**TO:** Planning Commission  
**FROM:** Ben Prchal, City Planner  
**AGENDA ITEM:** The Legacy at North Star Fourth Addition – Final Plat and PUD Plans  
**REVIEWED BY:** Ken Roberts, Planning Director

### FINAL PLAT/PLANS: LEGACY AT NORTHSTAR 4TH ADDITION

## INSET B

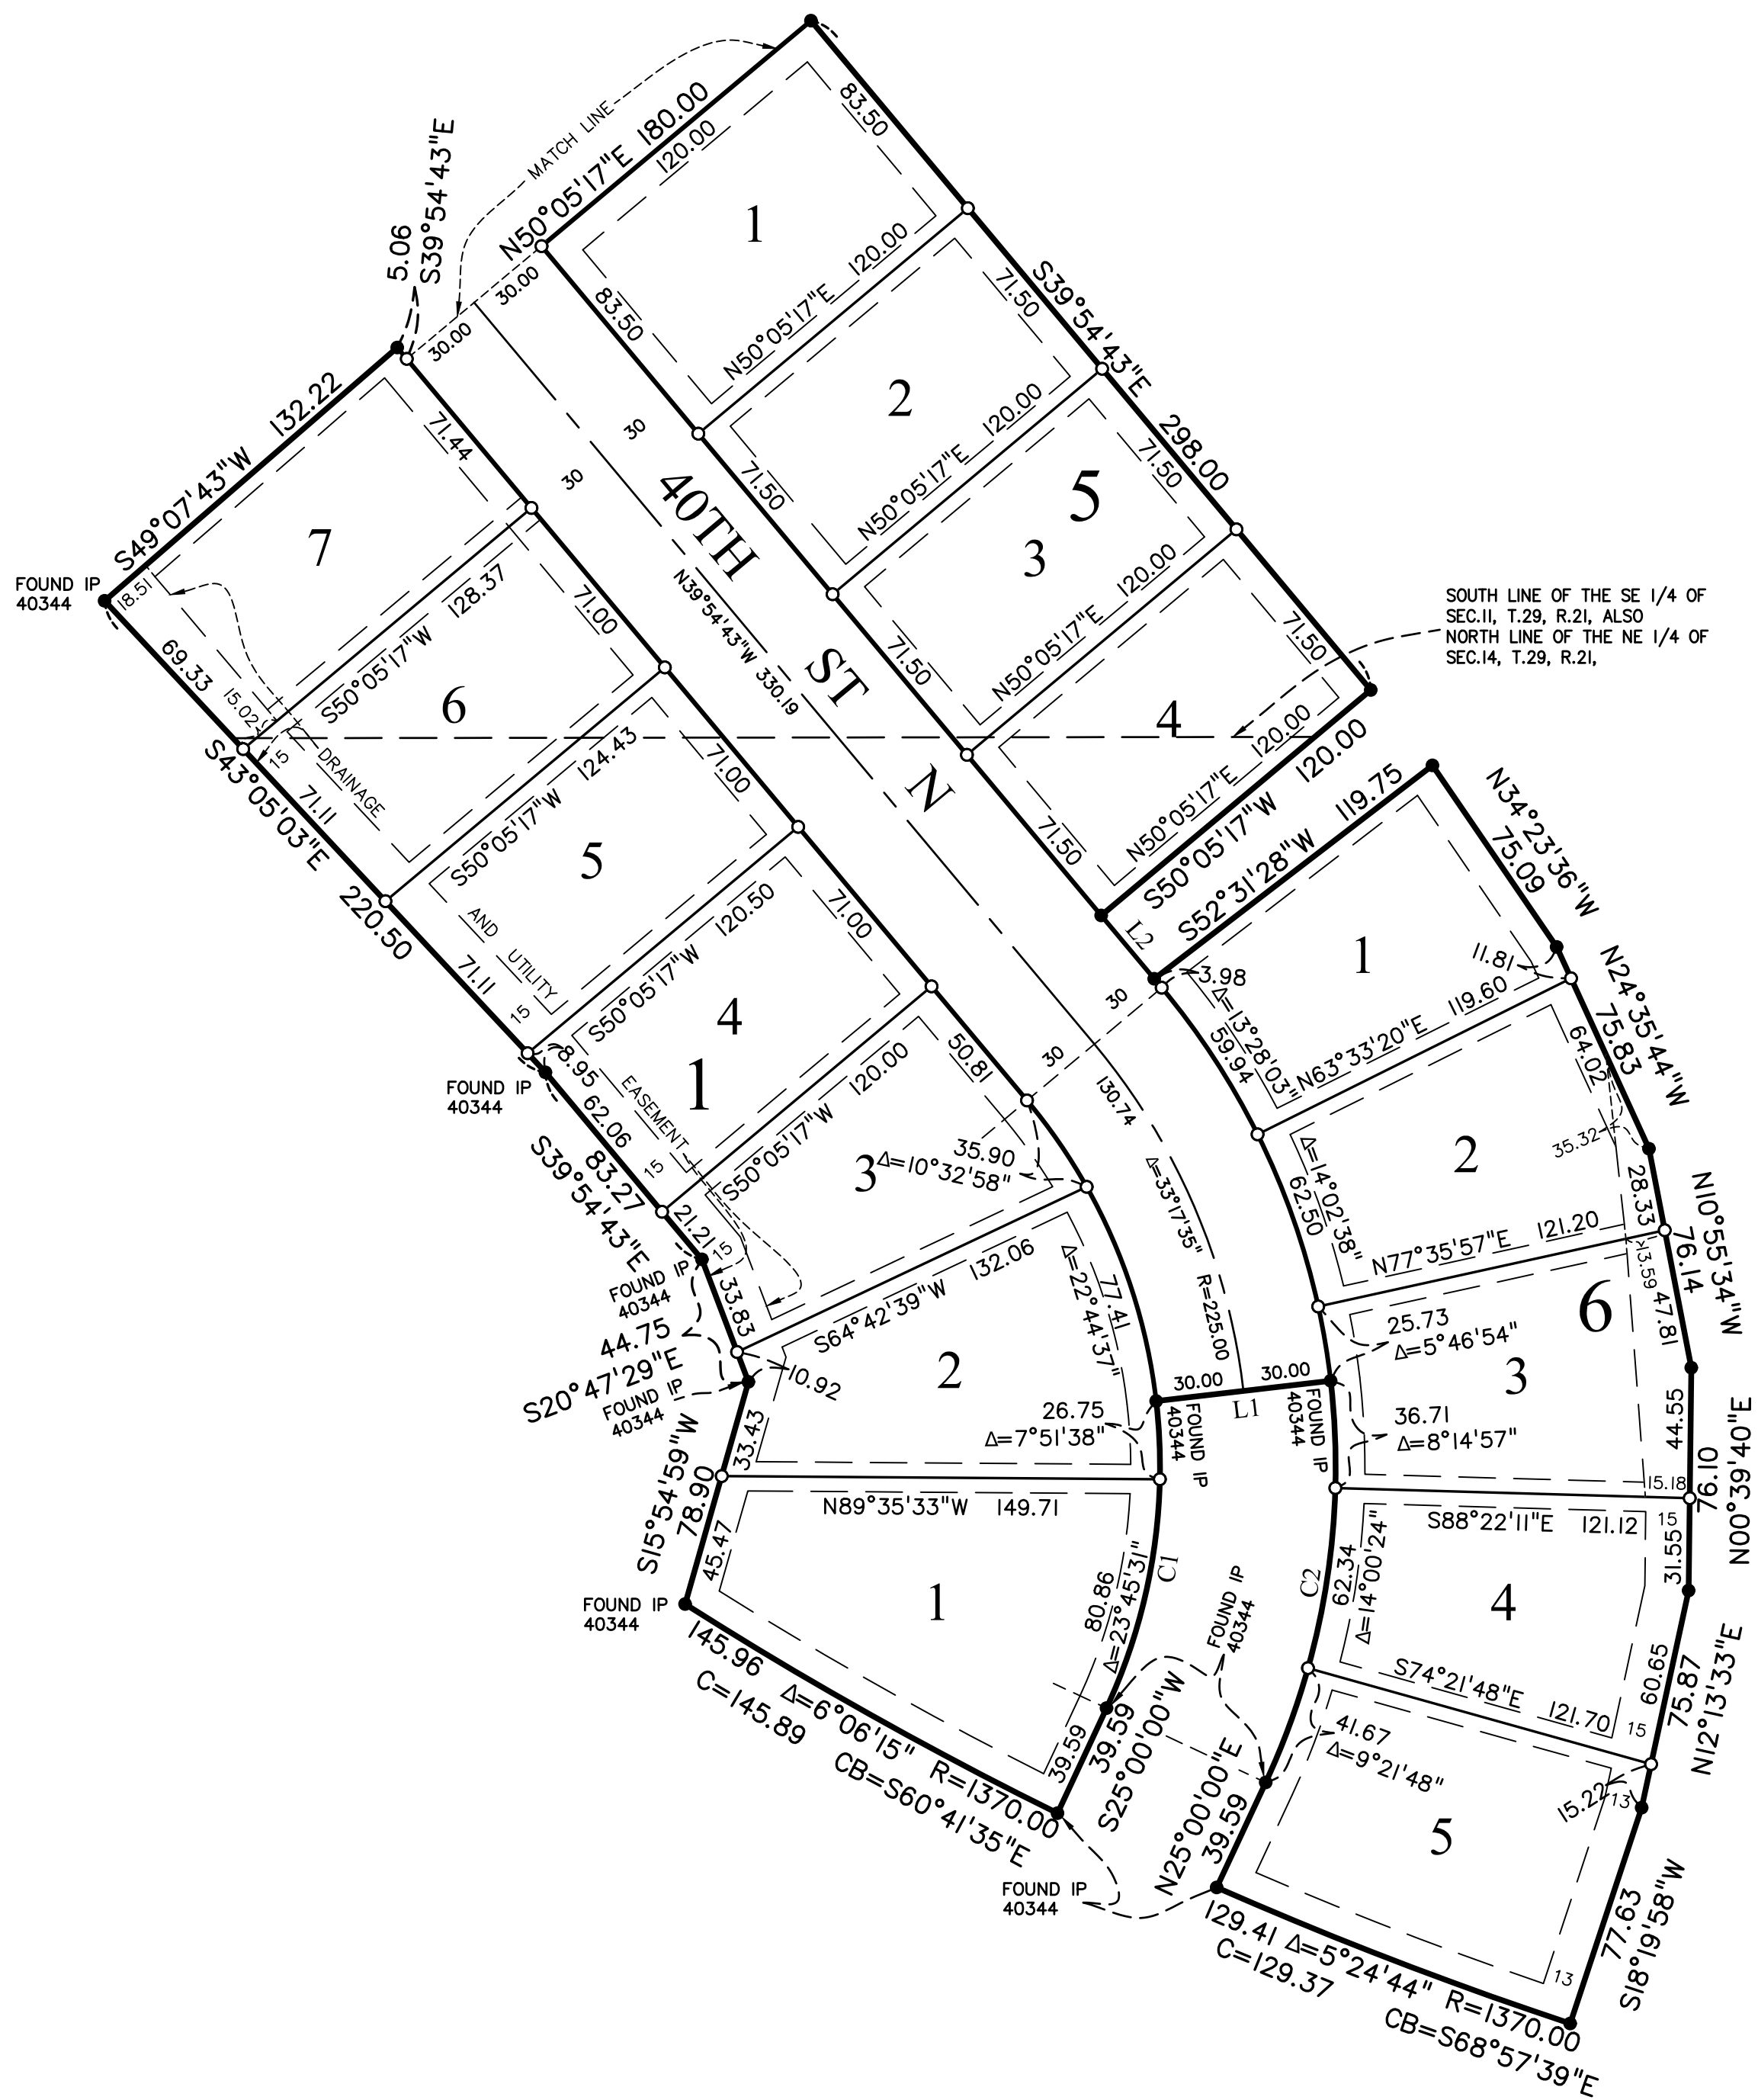
- Outlot A is shown as City owned on the Plans. This must be revised on the Plans to be HOA owned with a drainage and utility easement over all of Outlot A.

- All easements as requested by the City Engineer and Public Works department shall be documented on the Final Plat prior to the release of the Final Plat for recording. The Final Plat must be revised to show a drainage and utility easement over all of Outlot A.

- The rear yard lot easement must be revised on the Plat and Plans for Lot 10, Block 2. The easement should be a straight line while containing the localized HWL within the easement area.
